County of San Mateo - Planning and Building Department

RECOMMENDED FINDINGS AND CONDITIONS OF APPROVAL

Permit or Project File Number: PLN 2018-00397

For Adoption By: Board of Supervisors

Second Design Review Feedback

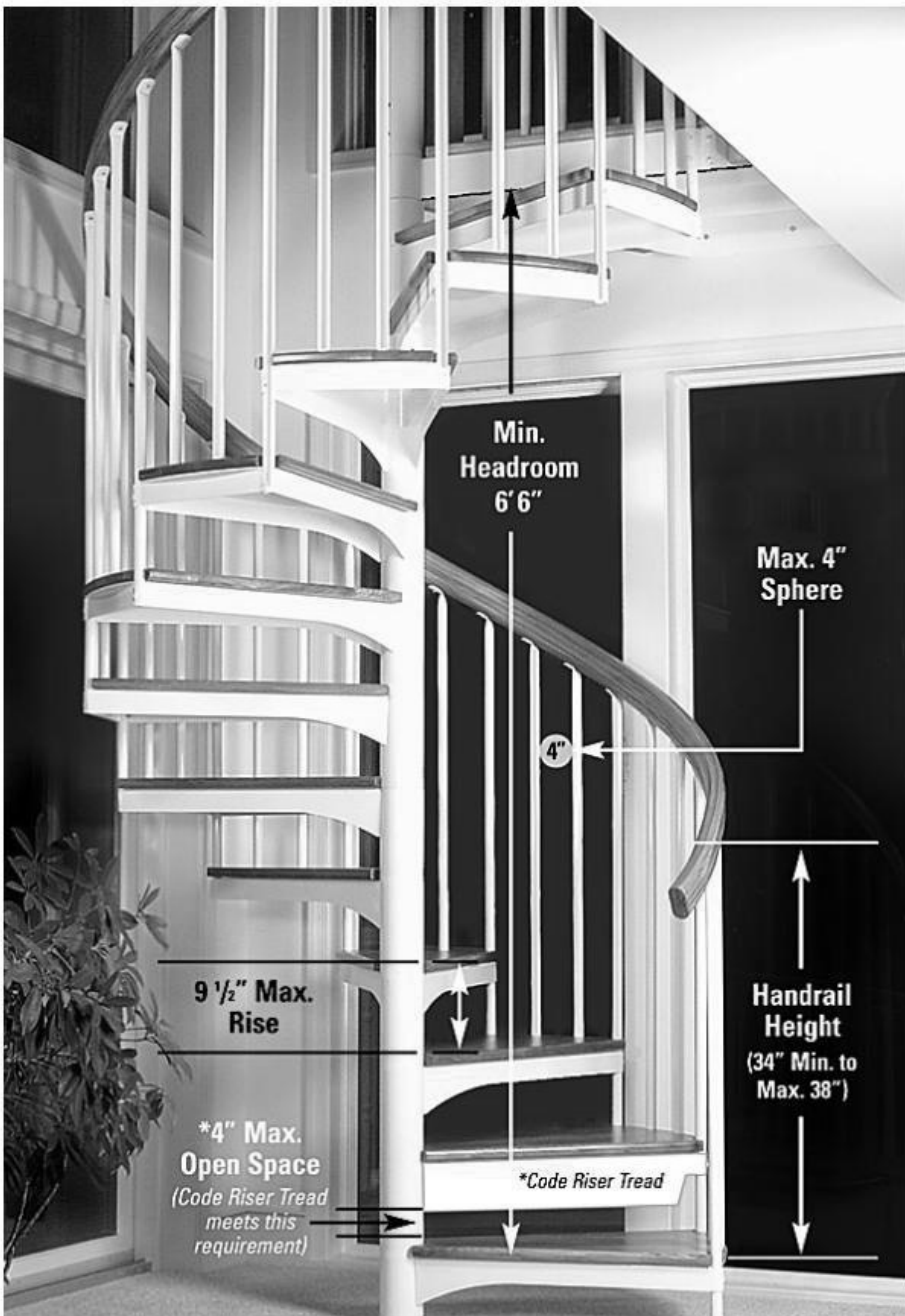
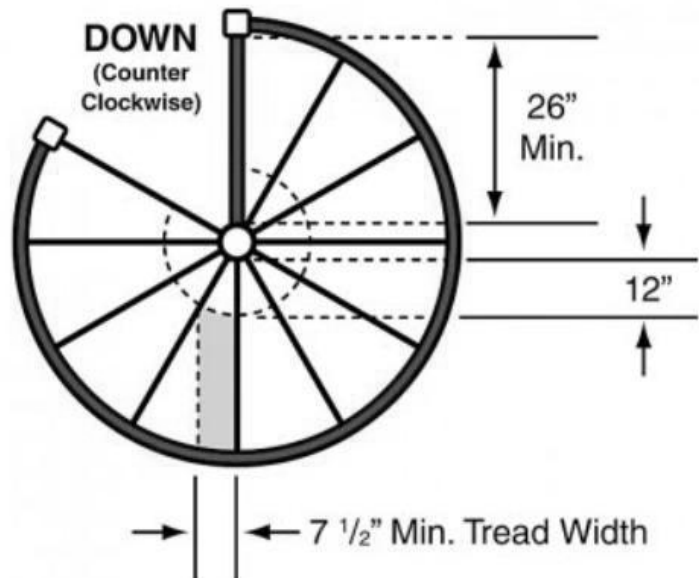
Recommendations:

1. Add a step up from garage into house.
2. If contemporary massing is intended, select a color palette more compatible with the predominantly pastel/earth-tone palette in the neighborhood. Consider overall composition for the color and materials. The current proposed palette is very busy with too many colors and materials in locations that do not create cohesive design.

3. Reduce the height of vertical wall sections to modulate the roof form to add roof articulation.
4. Provide greater roof and wall articulation to mitigate the boxy form of the residence per Section 6565.20(D) Elements of Design 1.c, Second Stories.

6. Remove or reduce closet pop-out on 2nd floor, east side so that it is not in the setback. Ensure all exterior walls on all floors are represented with setback dimensions on the site plan.

7. Provide tread and riser dimensions for the spiral stair access to the upper roof deck that is compliant with applicable San Mateo County Building Code Regulations.

ROOF / DECK PLAN

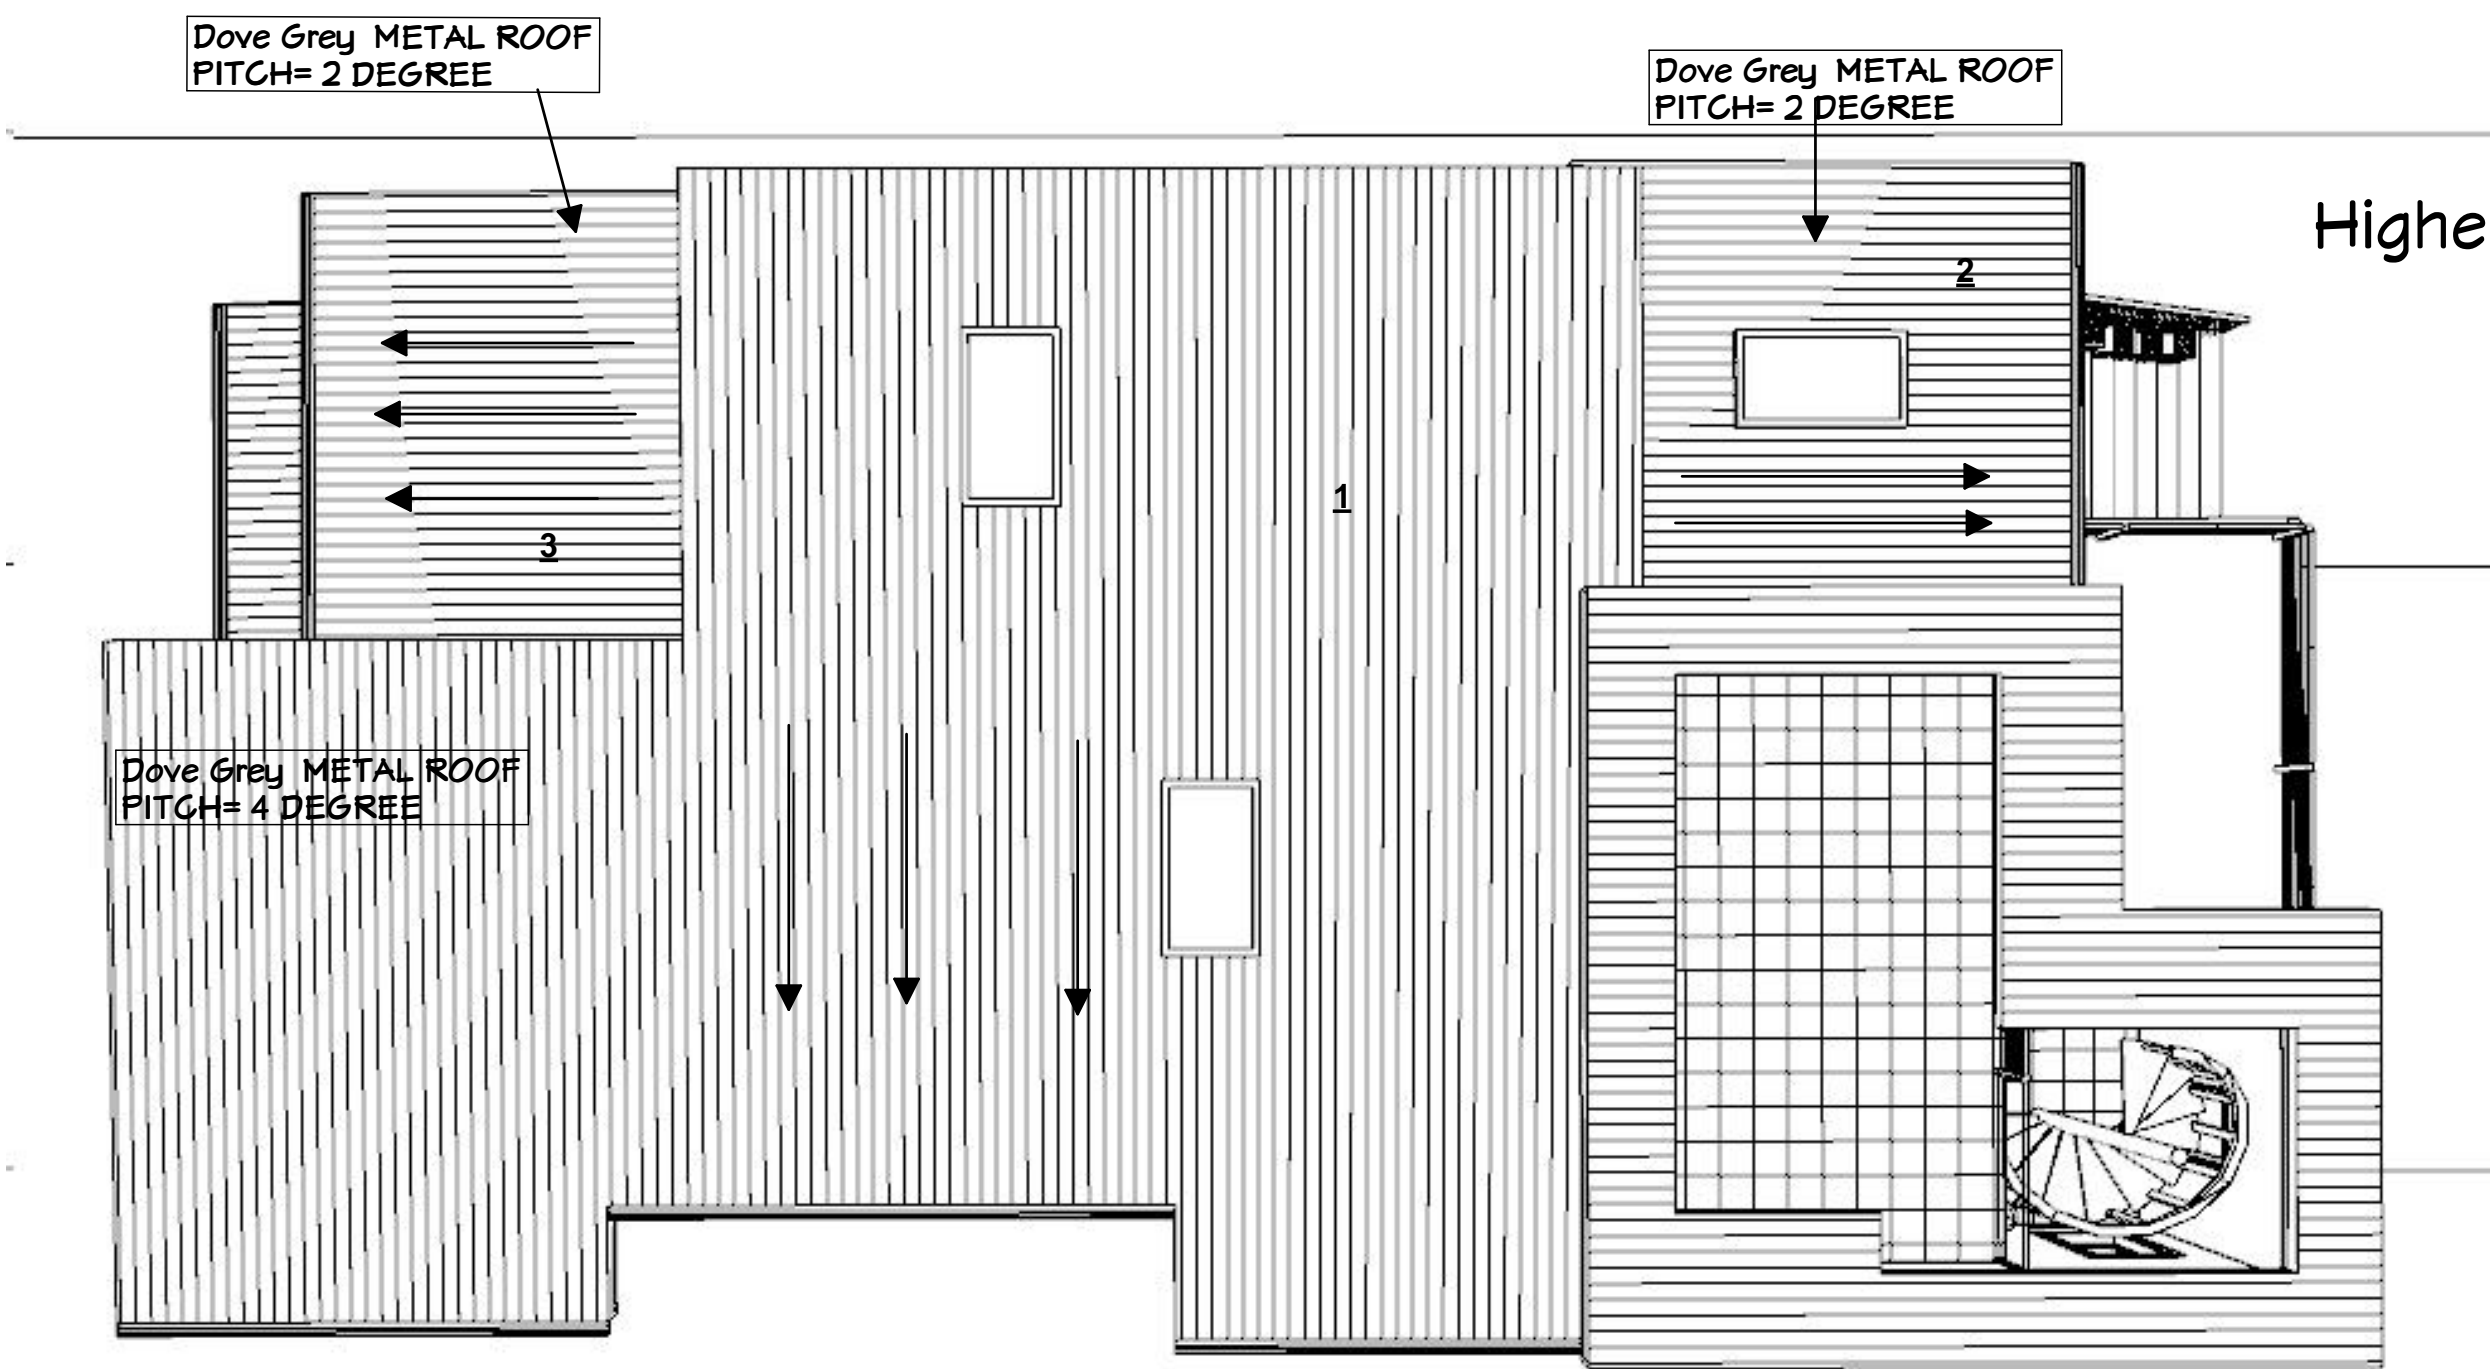
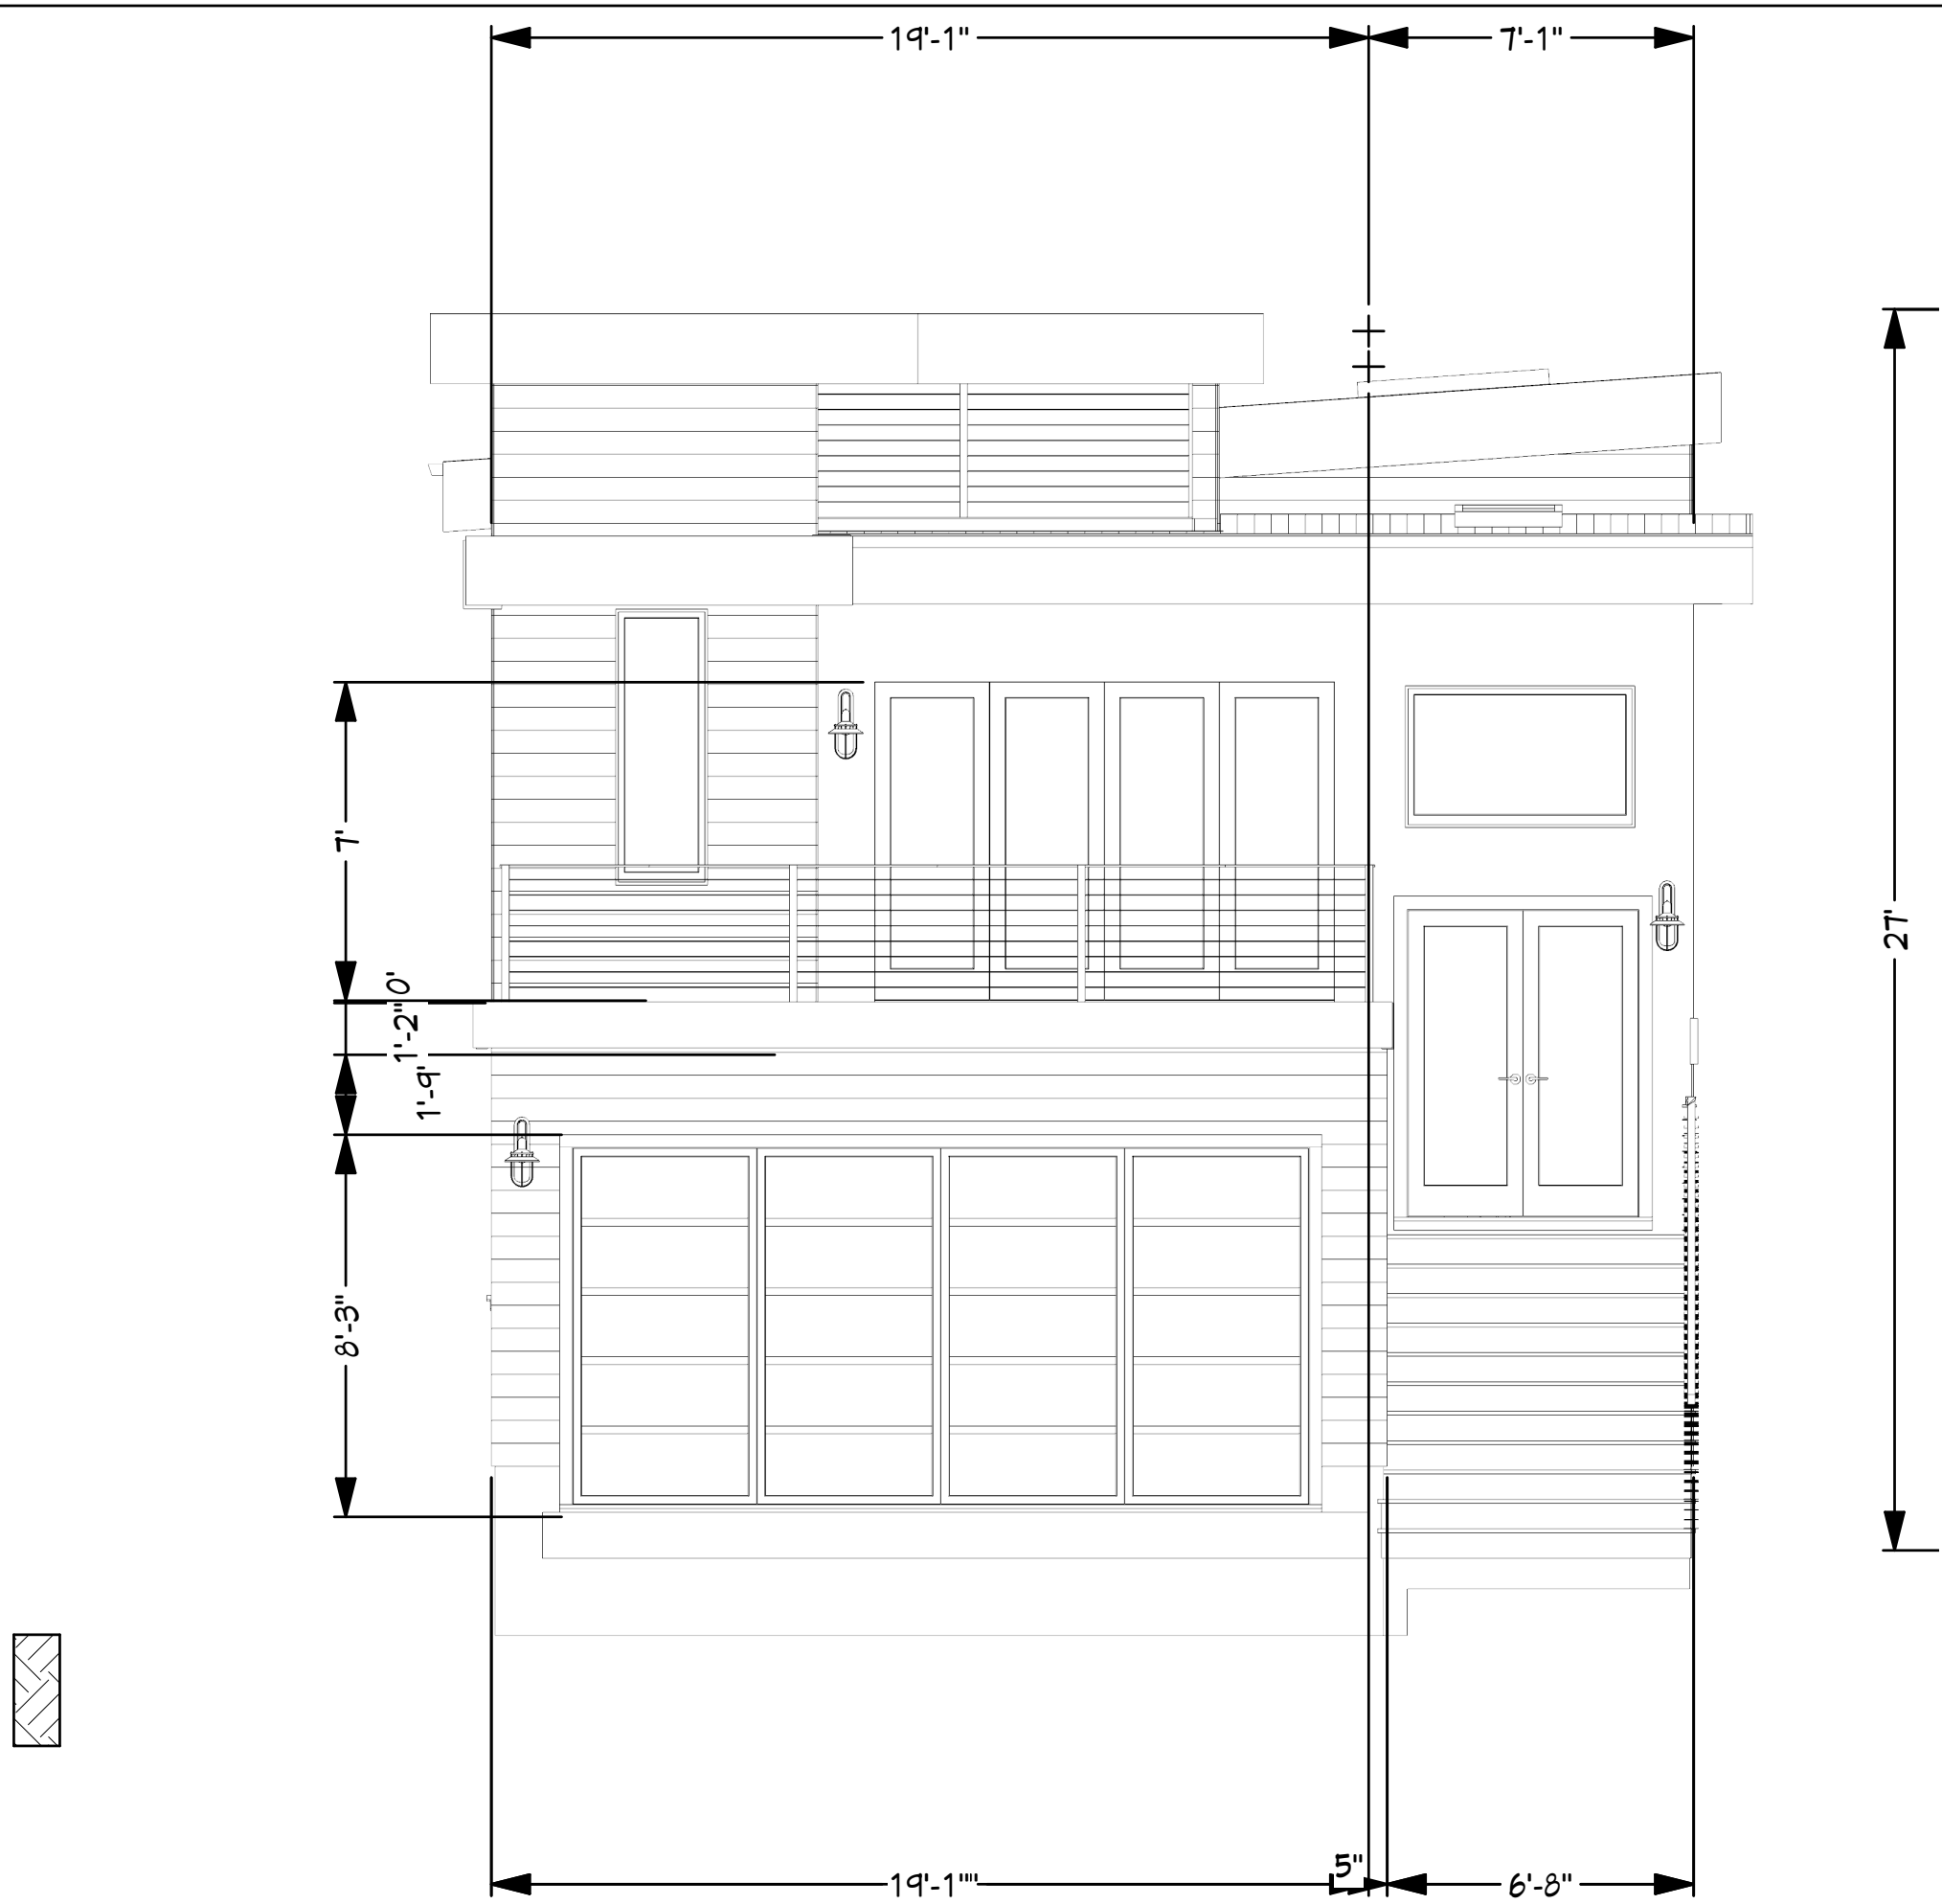
- ROOF # 1 AREA = 794 SQFT
- ROOF # 2 AREA = 148 SQFT
- Roof # 3 Areas = 128 SQFT
- ROOF DECK AREA = 120 Sft now (Rev 3= 194 SQFT) (Rev 2 = 300 SQFT)

EXTERIOR LIGHTENING PLAN

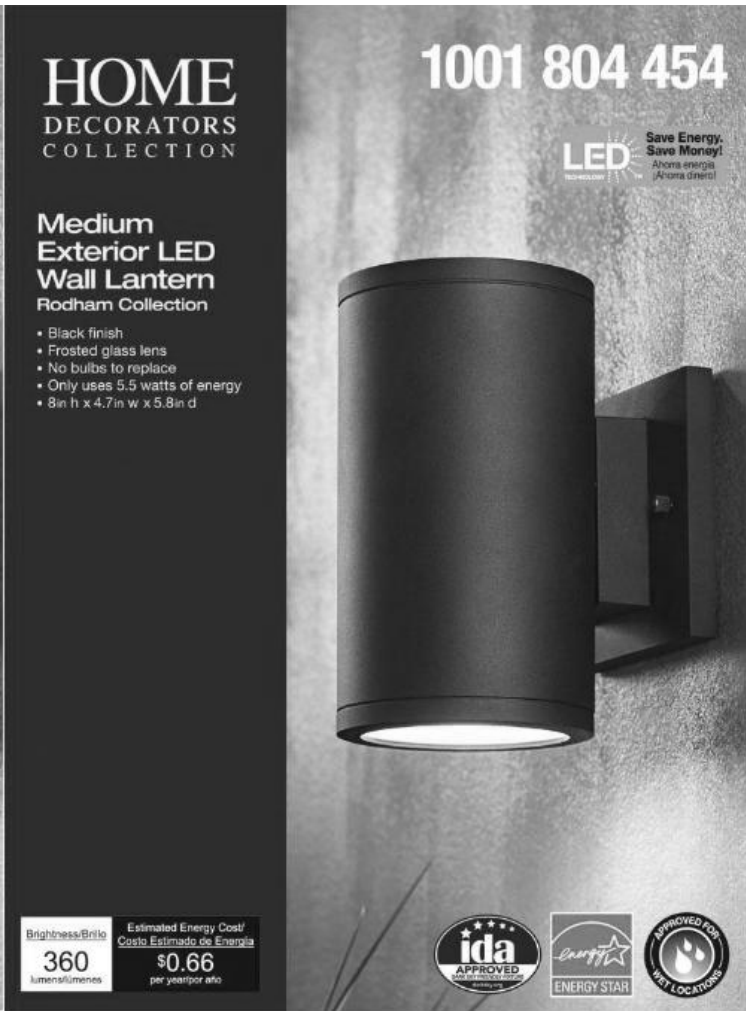
1. Outdoor lighting reduced to one light feature near door only.
Redesign: Remove all lightening. Total exterior light now reduced to 5. 2 for front patio and then 1 each exterior door.
